ST IVES MINE SITE

Gold Fields Ltd St Ives Gold Mine – Beyond 2018 Project (Revised Proposal) (Case Number CMS16335)

Section 43A Application – Change to Proposal

Summary

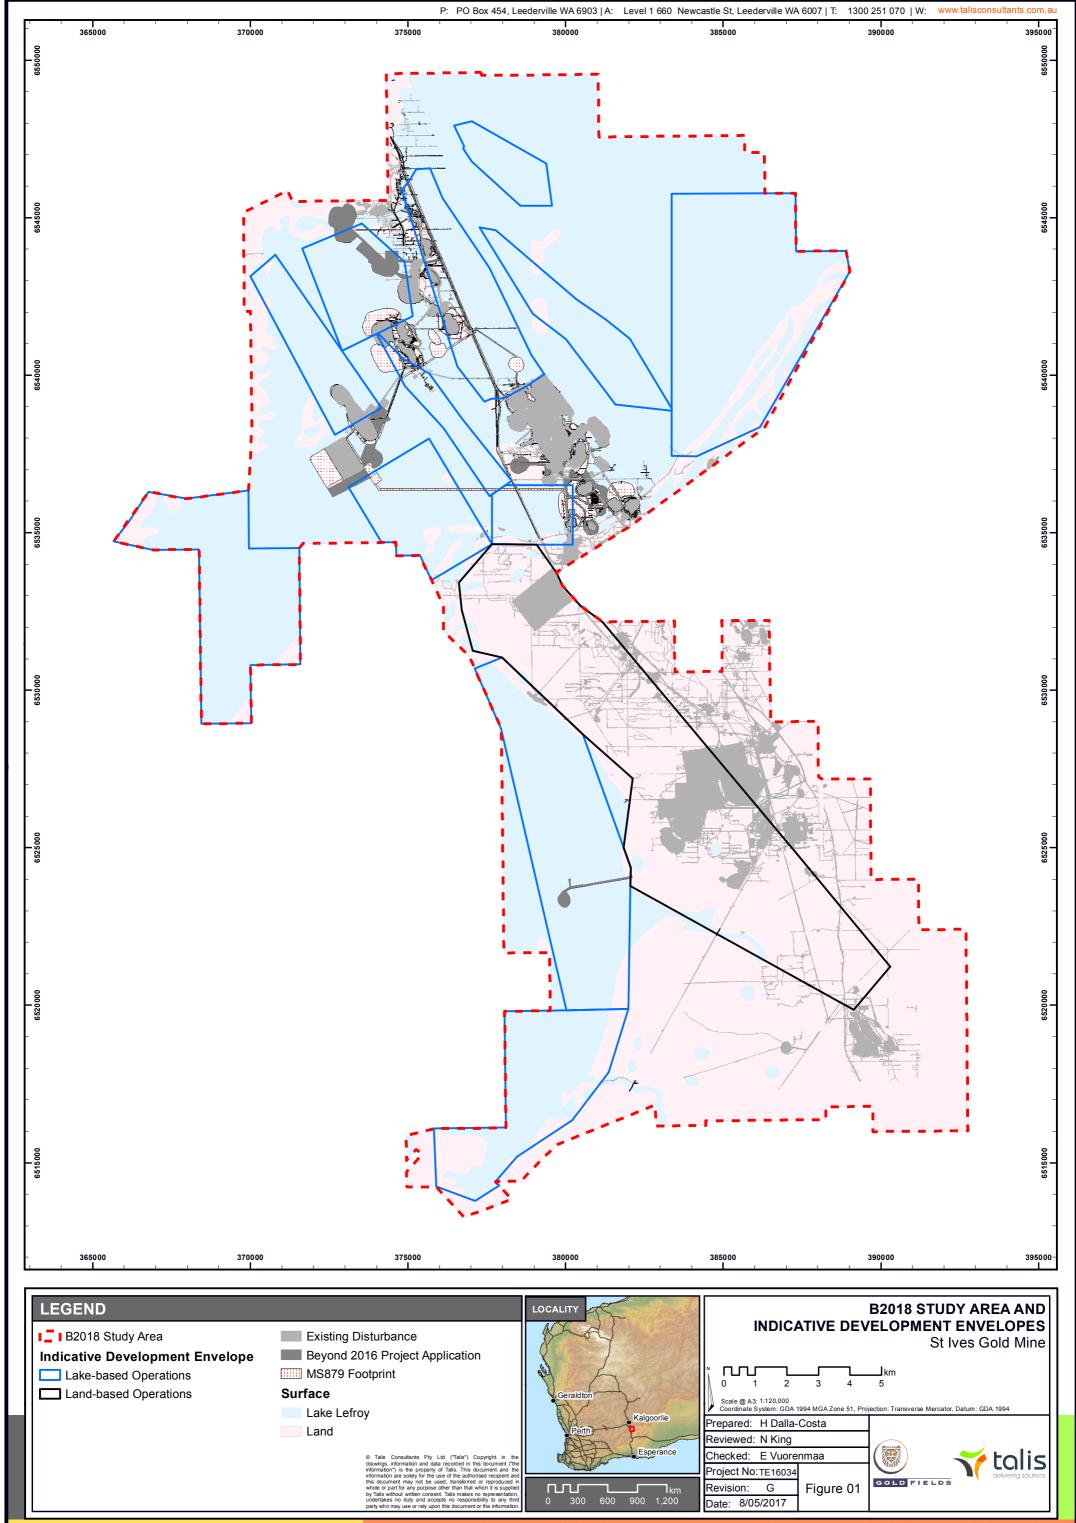
A revised Study Area and Development Envelope figure (Figure 2) along with the original Referral figure (Figure 1) are enclosed with this letter. As shown in the Figure 2, the revised Development Envelope covers a larger, continuous area including all the smaller Indicative Disturbance Areas provided as part of the Referral. As a result of this change the Development Envelope area has increased in size compared to that which was referred. This approach provides greater flexibility for the placement of miscellaneous linear infrastructure such as roads and dewatering discharge structures. Notwithstanding this altered presentation, the original scope of the proposal referred remains the same at up to 5,000 ha of disturbance, consisting of:

SIGMC does not consider the proposed change to be significant in nature as the proposed disturbance area does not change and the scope of the proposal and total maximum disturbance is consistent with what was originally referred to the EPA. Consequently, the potential environmental impacts originating from the 'revised' B2018 Project are expected to remain the same as in the original Referral. SIGMC will also continue to endeavour to exclude areas with higher environmental values from the mine plan.

Comparisons have been made between the current (~7.5 GL) and potential maximum (60 GL) dewatering scenarios, assessing summer and winter rainfall scenarios for 1:20 and 1:100 Average Recurrent Interval (ARI) events. The modelling undertaken has shown that the main impacts of dewatering operations relate to a rise in water levels seen next to the causeway, adjacent to the current operational areas. Due to the large surface area of Lake Lefroy, the impacts of the maximum dewatering discharge (60GL), relative to present day water levels, are insignificant at the positions compared thus far.

As expected, the flood extents resulting from the winter 1:100 rainfall scenario coupled with a 60GL dewatering discharge were the greatest within a number of locations along the fringe of the riparian vegetation areas. However, it was noted that no significant changes in the flood extents were observed between the scenario above and the 1:100 ARI winter scenario. This suggests that the impact of dewatering at and below the maximum 60GL annual dewatering volume is minimal compared to the natural flooding of Lake Lefroy. Consequently, increasing the maximum dewatering volume from 30GL to 40 GL annually to better cater for operational needs is not expected to significantly change the environmental impacts originating from B2018 Project.

- Lake based disturbance up to 200 ha per year over a ten year period with a total maximum disturbance of up to 2,000 ha; and
- Land based disturbance up to 300ha per year over a ten year period with a total maximum disturbance of up to 3,000 ha.
